# **Bolivar - Right Bank Root Creek**

**Bolivar, New York**

## **Periodic Inspection Report No. 1**

**Date of Inspection: June 12, 2017**

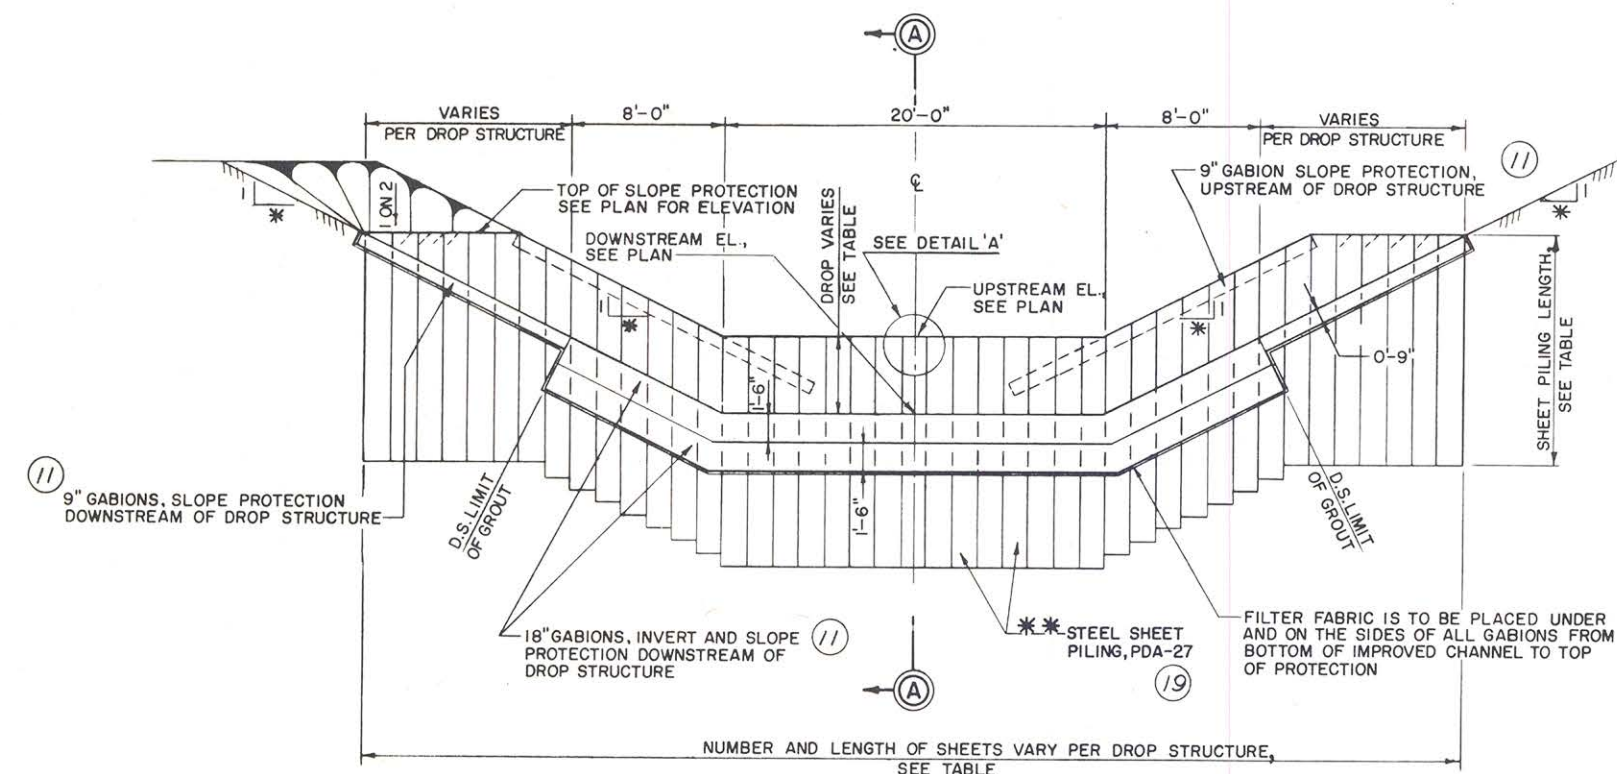
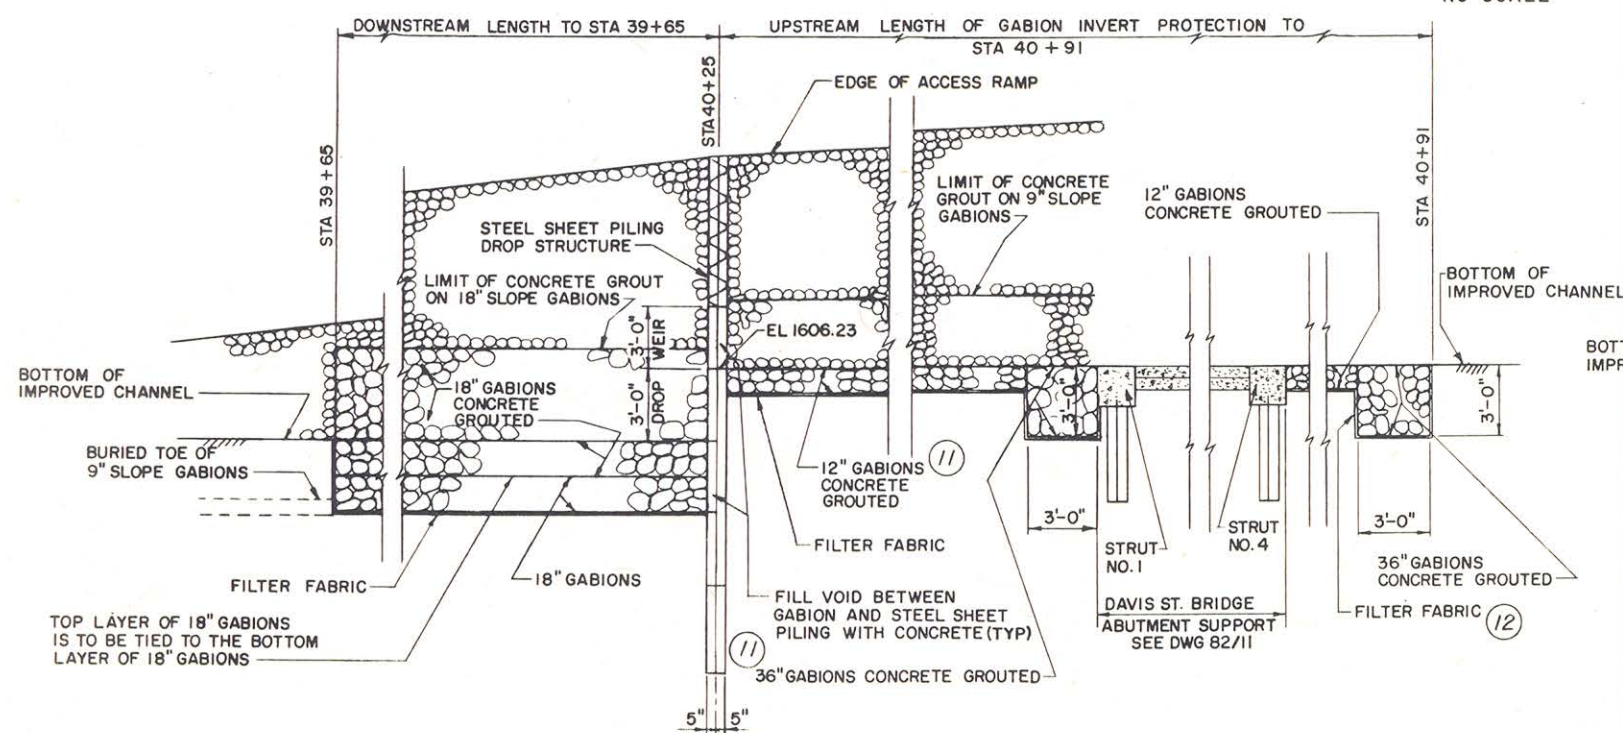
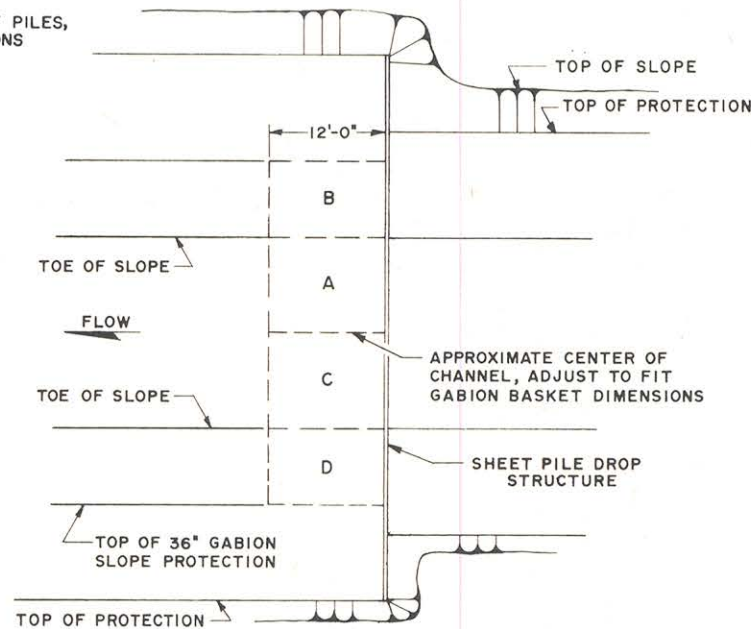
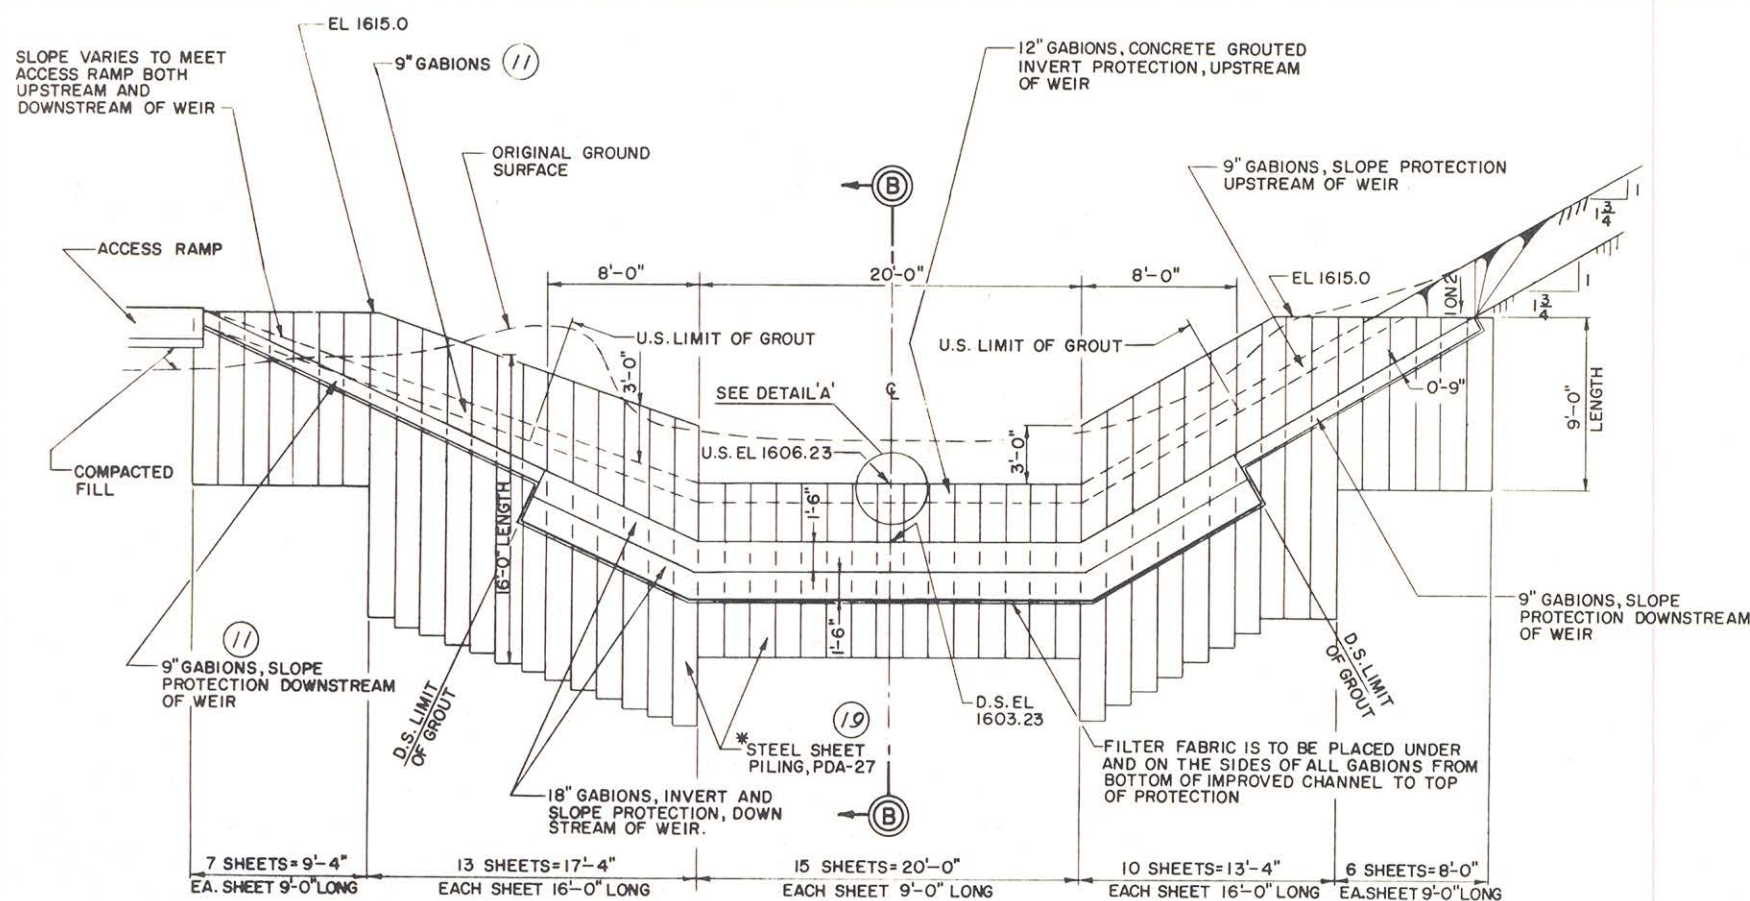
Page 6, Section 3.4, Drop Structures, The 1975 DPR, PLATE 1 Appendix II and the LRP District LFPP maps and data sheets show six drop structures not five. Verify drop structures and reference table in report and where it was from.

Note: There is a sixth drop structure in the channel improvement section constructed by NYSDOT located at Station 27+37 according to Design Drawing No. 038 pa.1-P1-82/3.
